## Memo

**From:** Plan Review Committee of the Verona Environmental Commission

**Date:** August 3, 2022

**Re:** **Case # 2022-04: Major Development**  
1 Sunset Avenue [Block 303, Lot 4]  
Verona, New Jersey

**UTILITY PLAN**

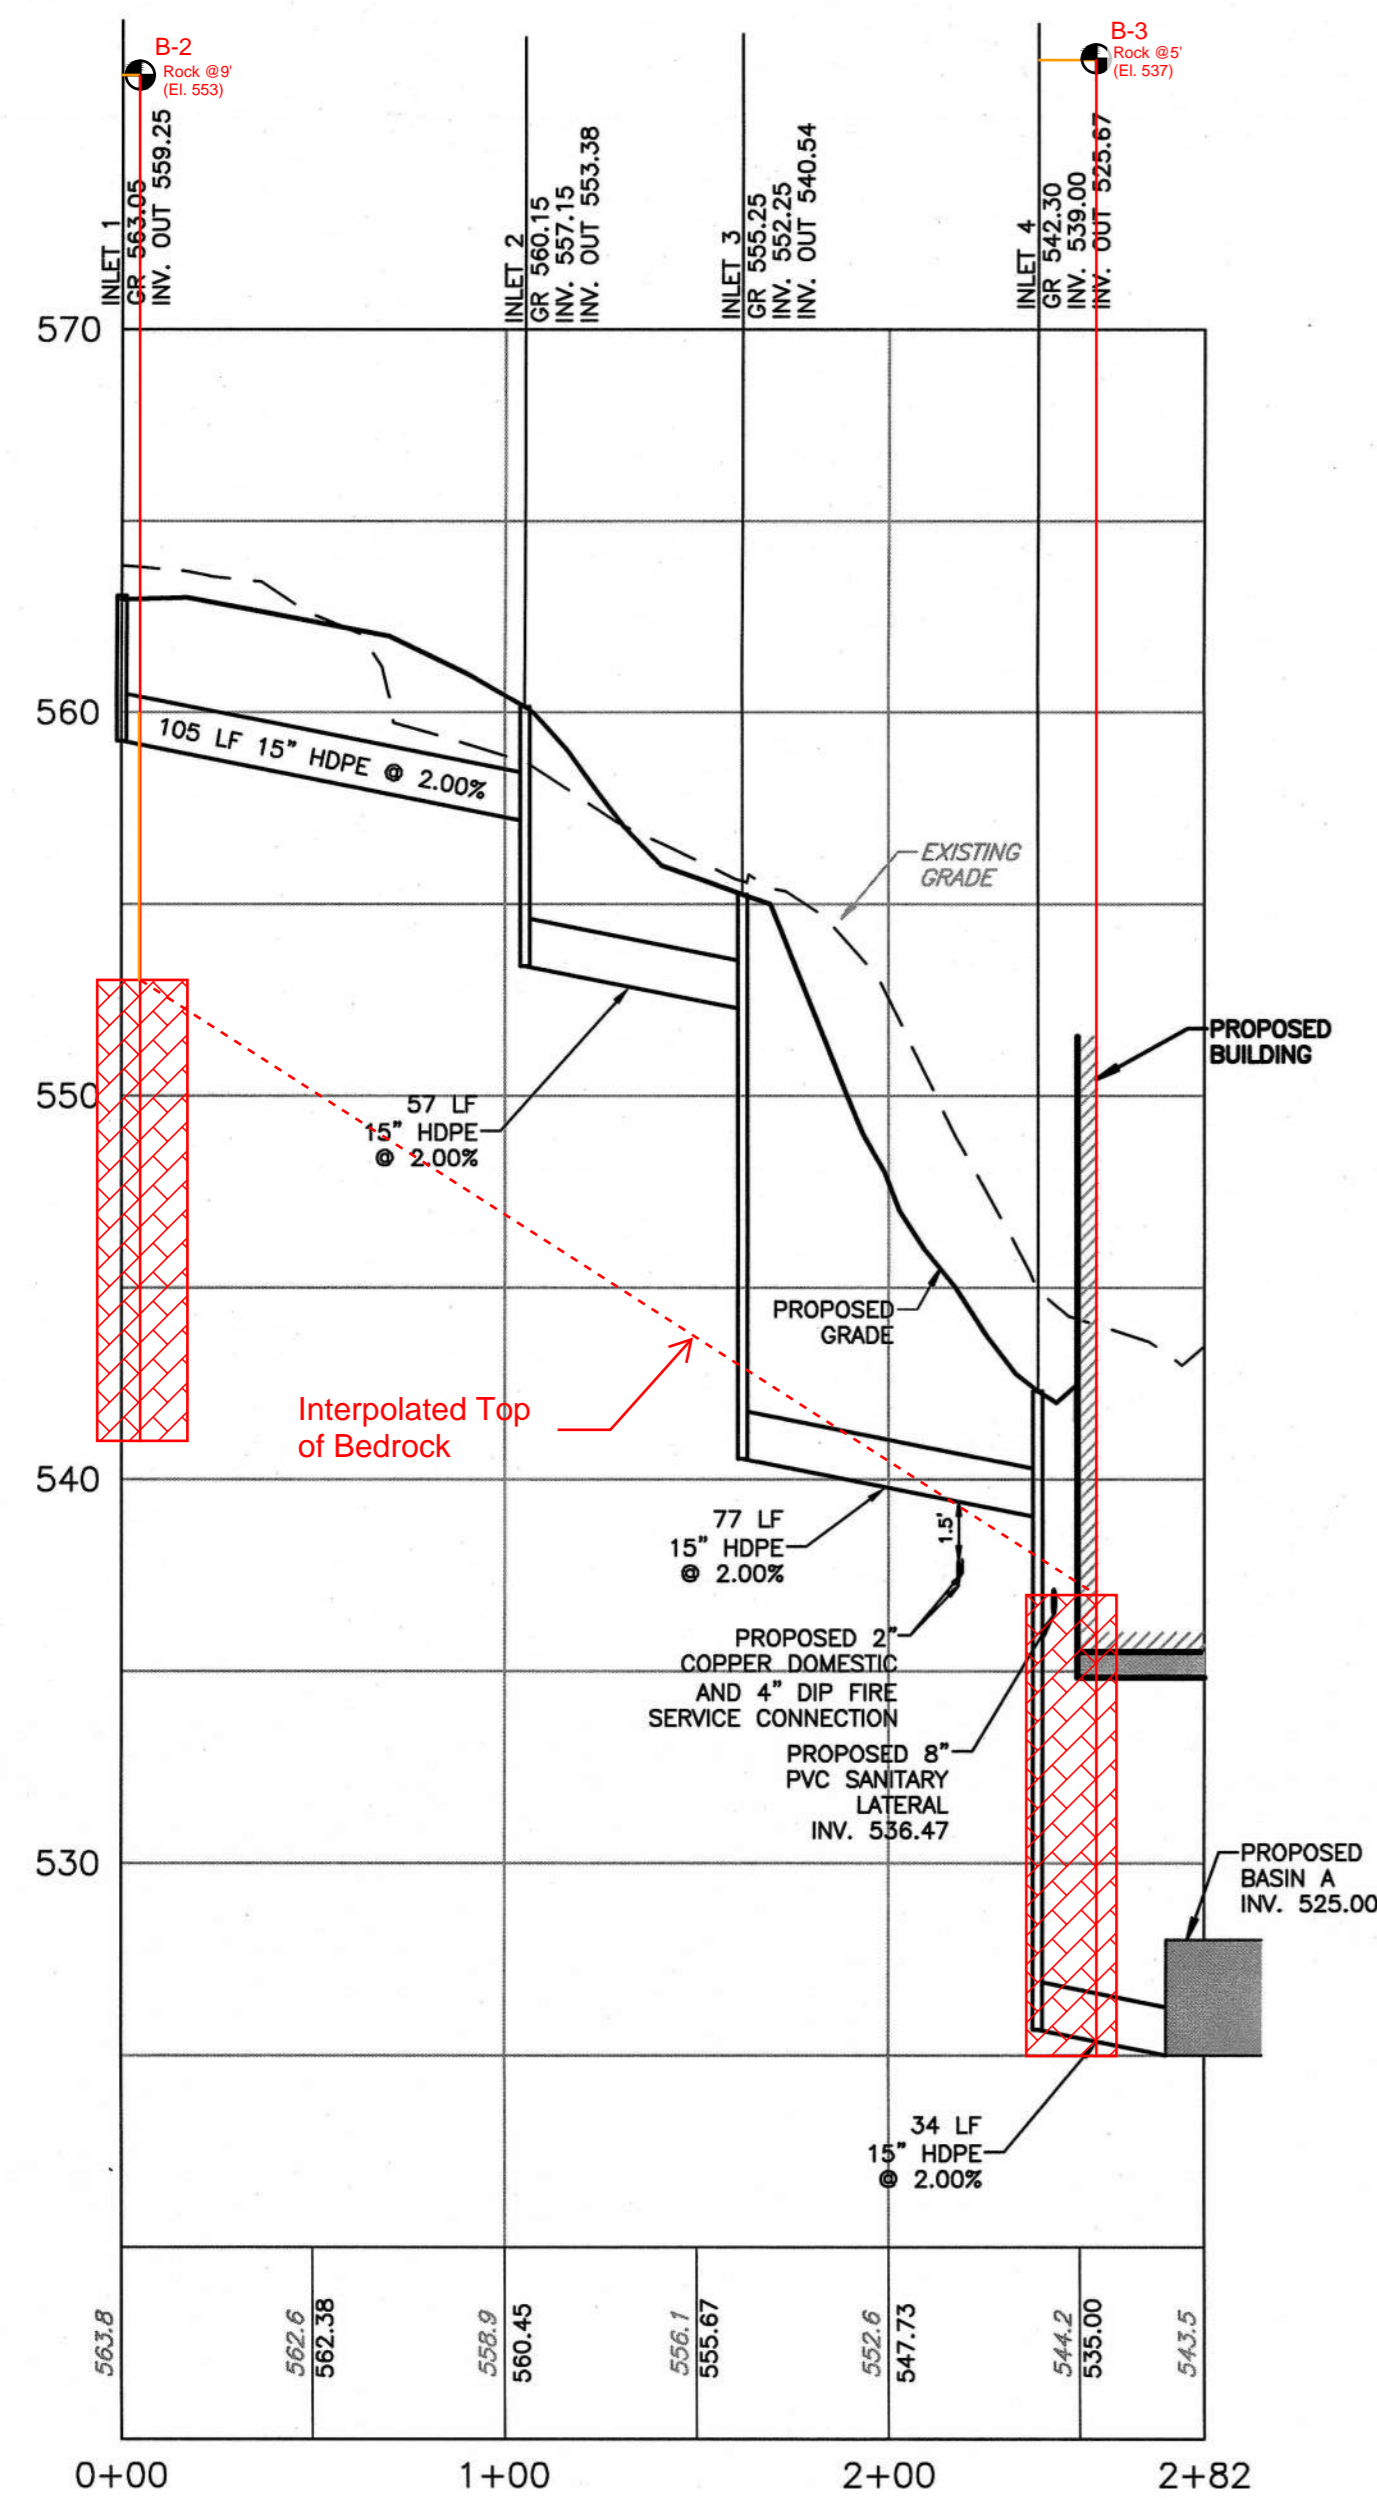
2. There were only six subsurface explorations provided in the application and we understand bedrock is very shallow at this site, which can be very problematic for all structures and utilities that are designed to be below top of rock elevations (as depicted in attached Sheets 7 and 8 annotated by the VEC). Bedrock was encountered in five of the six test borings with depths ranging from 2 to 9 feet below existing grades. NJ Building Code §1803.3.1 requires a minimum of one exploratory test boring to rock for every 2,500 ft<sup>2</sup> of built-over area; base on the size of this development we would expect a minimum of 432 test borings be documented or a justification from the Applicant's engineer as to why the minimum number was not completed.
